Final Initial Study/Mitigated Negative Declaration 619–625 California Drive Development Project City of Burlingame, San Mateo County, California

RE: Comments on 619-625 California Drive Development Project ISMND

Coffee Family Trust (COFFEE)

Figure 6
Project Site Plan

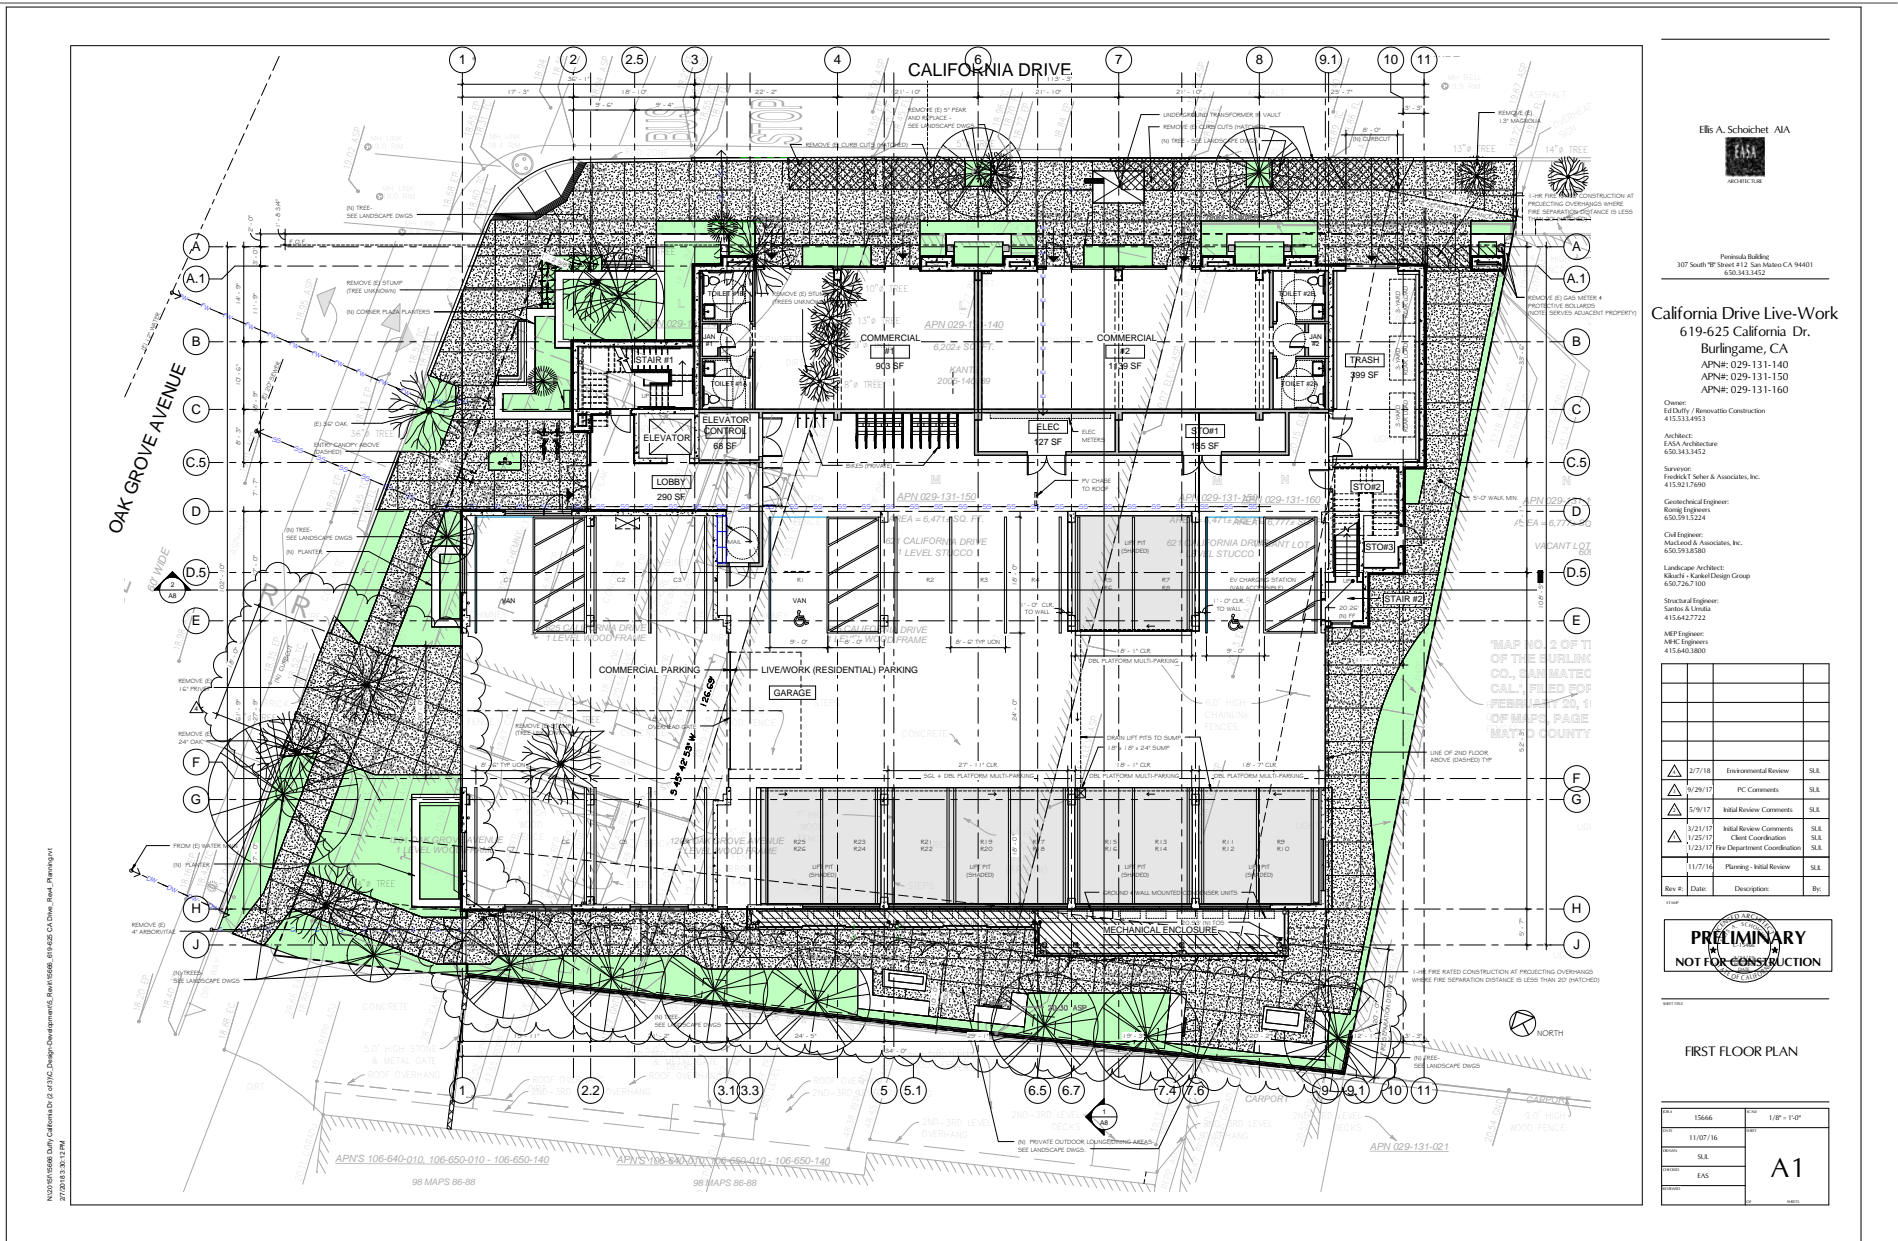
2. The ISMND does not list Transportation/Traffic as a potentially significant environmental impact in the Table in Section 2, page 23. We strongly disagree with this assessment. The Project's only driveway is at the extremely congested intersection of San Mateo and Oak Grove Avenues. The ISMND Traffic Impact Analysis (Appendix H) does not include this important non-signalized intersection. There are very significant unstudied traffic congestion impacts from parents dropping off and picking up Burlingame High School students and especially from customers accessing the laundromat rear entrance via San Mateo Avenue. We often witness Oak Grove Avenue (northeast bound) backups of 10 to 15 cars, and strongly disagree with the assessment in paragraph 4 on page 14 of the traffic study (that there are only backups of a few cars at the driveway). Lyft and Uber pickups/drop-offs can exacerbate the congestion and these may increase due to the Project. Additionally, the above-mentioned impacts do not necessarily occur during peak AM and PM traffic periods, the periods studied in the Traffic Analysis. Since this Project is a live/work building (with commercial components), the Project driveway should be located on California Drive (a commercial avenue), not on Oak Grove Avenue (a residential avenue). 2

San Mateo Avenue meets Oak Grove Avenue directly across from the proposed project driveway. The "Nearby Driveways" section, in both the Transportation Analysis of the IS/MND (Appendix H) and the updated Transportation Analysis, which replaces Appendix H of the Draft IS/MND, studies the San Mateo Avenue/Oak Grove Avenue intersection and references it as an access driveway given its roadway characteristics (i.e., low volumes, short distance, operates as a commercial drive aisle). The report notes that intersection operations at this driveway (San Mateo Avenue/Oak Grove Avenue) are not expected to be significantly impacted by the proposed project due to the small number of trips the project is estimated to generate.

In addition, field observations showed that eastbound vehicle queues at the California Drive/Oak Grove Avenue intersection were 2 to 3 vehicles. Calculations performed by Hexagon Transportation Consultants show that the average eastbound vehicle queue would be about 4 vehicles, which would not block the project driveway. The calculated 95th percentile queue length is 8 vehicles, which would block the driveway. However, a vehicle queue of that length would only occur on 5 percent of the signal cycles. With the addition of project-generated traffic, the 95th percentile queue is estimated to be unchanged. Therefore, the proposed project is expected to have a minimal effect on traffic operations at the California Drive/Oak Grove Avenue intersection and at the San Mateo Avenue/Oak Grove intersection.

In regards to locating the driveway on California Drive as opposed to Oak Grove Avenue, California Drive has a greater volume of traffic, so the driveway would be more difficult to access compared to the proposed access on Oak Grove Avenue. Furthermore, northbound vehicle on California Drive turning left to enter the project could provide conflicts with northbound vehicles approaching or queuing to turn left onto Oak Grove Avenue.
